Access Compliance Report

Public Rights-of-Way

| Intersection ID: 13414 | Main Street: MCCLINTOCK_RD | Cross Street: ST_JULIEN_ST | Location: W |
| ADA ID: C59EE89BBA06 | Ramp Type: Perp | Initial Pass/Fail: Fail | Overall Compliance: No |

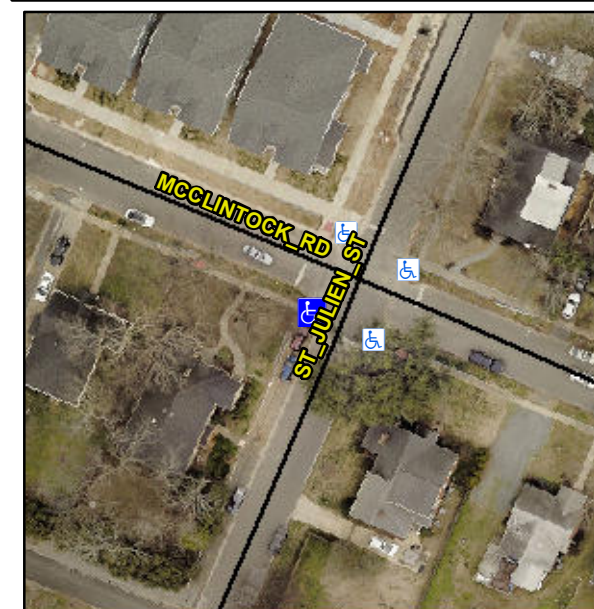
Not Found, R304.2.2, R304.5.3

| Compliance | Description | Data | Compliance | Description | Data |
|------------|-----------------------|-------|------------|-----------------------------|------|
| N/A | Ramp Length (in) | 64.5 | No | Ramp Slope (%) | 11.2 |
| Yes | Ramp Width (in) | 60.0 | No | Ramp XSlope (%) | 2.2 |

Remove & Replace Entire Ramp.
